Our Ref: PSM4010-008L

**RE: 44 CLUNIES ROSS STREET, PROSPECT
RESPONSE TO COUNCIL QUERIES**

Inset 1: Recent geotechnical investigation completed for Pad 7.

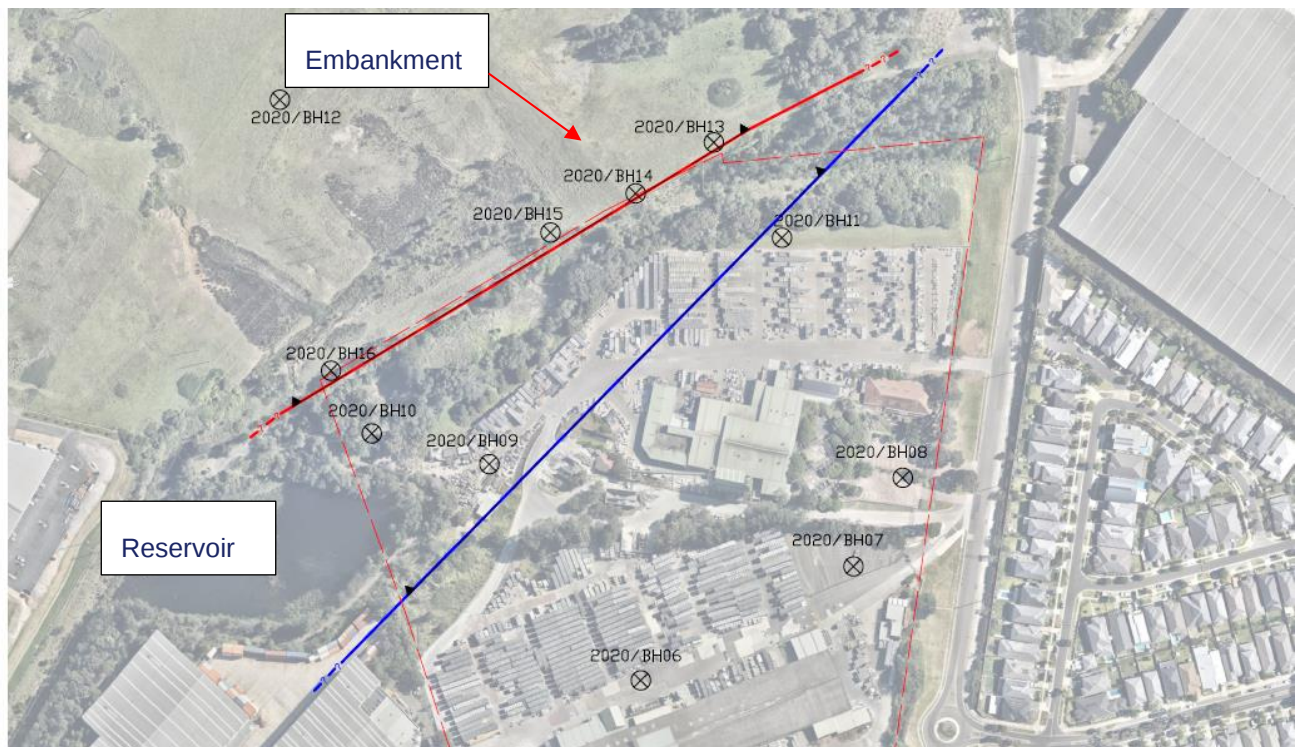
“Geotechnical Investigation report by PSM (dated 11 February) has suggested that Groundwater seepage was encountered at boreholes conducted onsite (boreholes 2020/BH09 and 2020/BH10). Results and recommendations carried out in this report must be considered (i.e. excavation methods, batter slopes and heights above the groundwater table etc) for the civil engineering designs.

Since these boreholes were tested at the location of proposed building pads (i.e. Pad 7), further investigation and possibly long-term groundwater monitoring is required to ensure that the proposed development does not impact the groundwater table and groundwater flows”

Additional geotechnical investigation has been completed for Pad 7, Inset 1 (ref. PSM4010-010L, 7 December 2020). The investigation presents groundwater observations including:

- Groundwater levels vary from RL 48.2 m to RL 51.8 m AHD
- Groundwater is typically shallower in proximity to the reservoir, Inset 1.

- The depth to groundwater may be shallower in proximity to the water storage (reservoir), Inset 1, which at the time of survey / measurement had a water level in the order of RL 54.6 m AHD

- The civil and structural designers shall consider the influence of the Girraween creek and associated stormwater infrastructure on temporary groundwater levels during peak flows. i.e. the embankment crest within Girraween creek is at approximate RL 57 m AHD ,Inset 1

Inset 4: Excerpt from Costin Roe BEL drawings with levels highlighted.

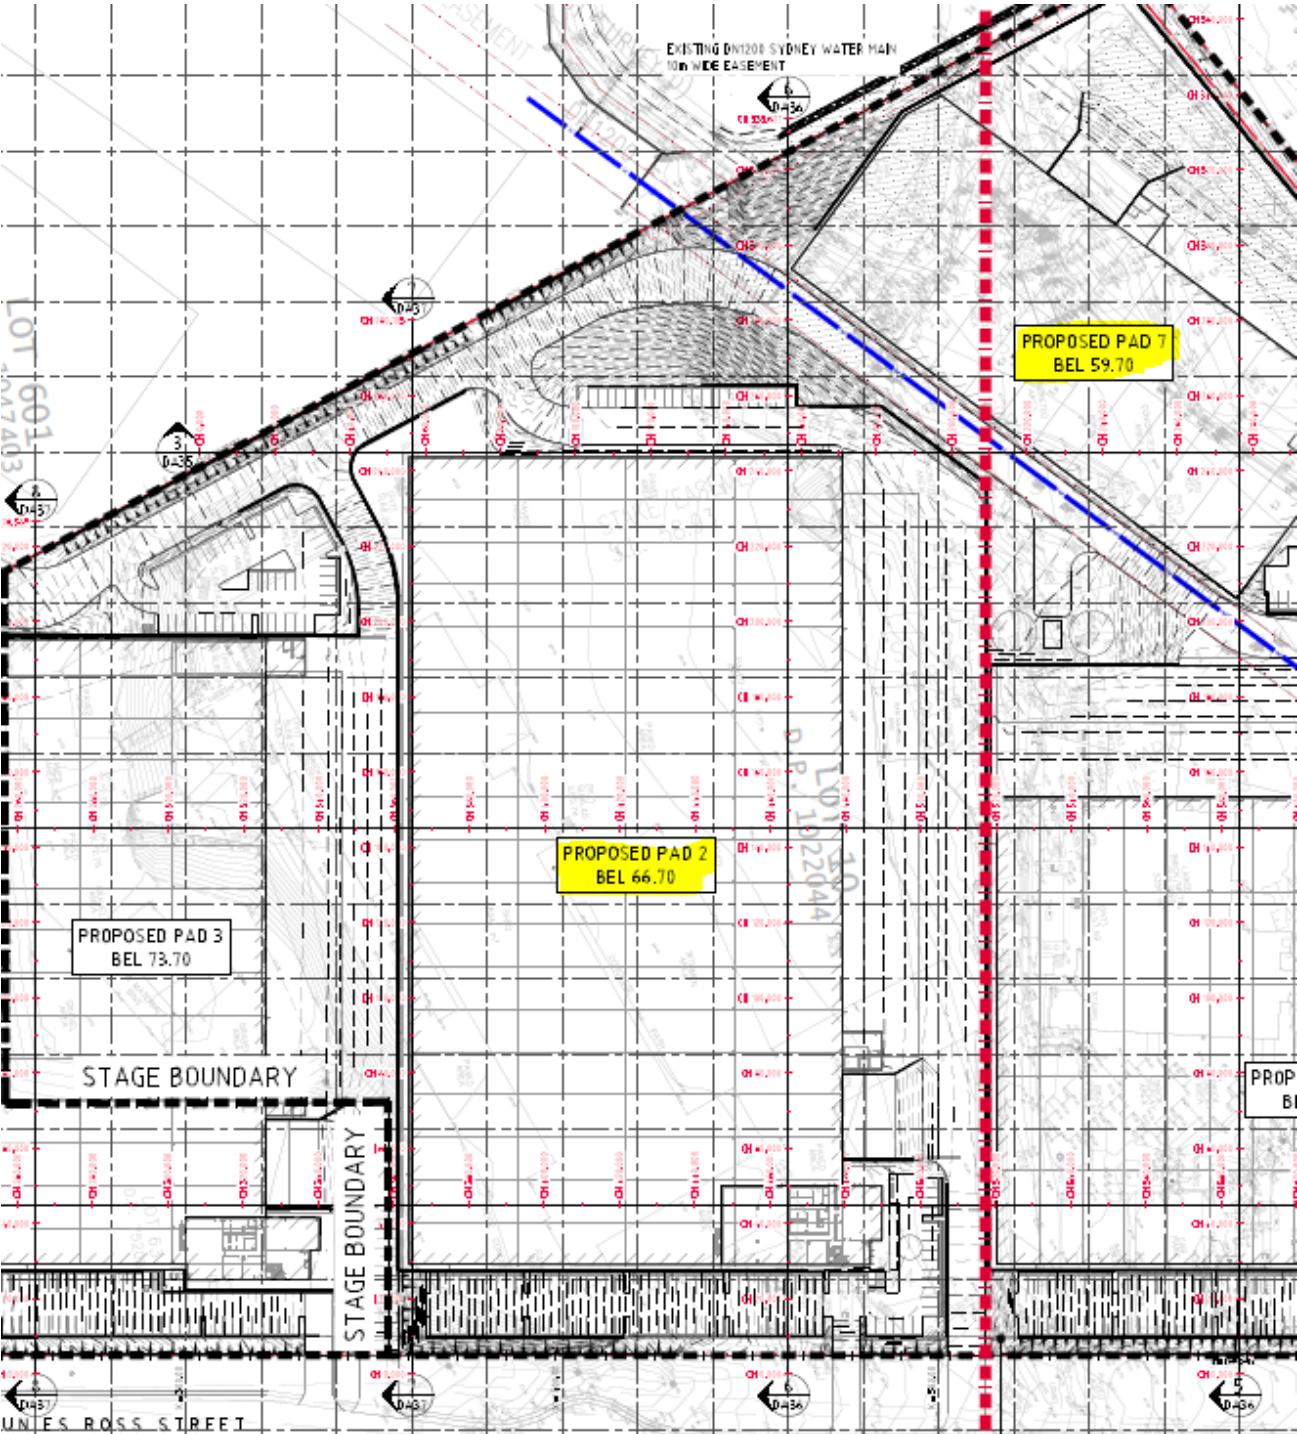
"In accordance with Clause 3.5, Control C12, development shall minimise cut and fill to protect existing drainage patterns and maintain integrity of the groundwater system.

In this regard, the proposed development is designed to require significant bulk earthworks with cut and fill in the order of 8m and 14m respectively, as identified on Page 11 of the Geotechnical Investigation (GI), which is considered excessive."

In areas of maximum cut, permanent groundwater has not been encountered in a series of investigations completed since October 2017. Furthermore, in the adjacent Blacktown Council land, groundwater was observed between RL 48.2 m to RL 51.8 m AHD. The proposed bulk excavation levels in the Cumberland Council area extend to RL 59.7 m AHD in the south west corner of Pad 7, Inset 4. As such the proposed cuts are unlikely to encounter permanent groundwater.

The civil and structural designers shall consider that in periods of wet weather temporary seepage may be observed in excavations for footing systems and the cut slopes (ref. PSM IGDA PSM4010-004L Rev1, 26 November 2020).
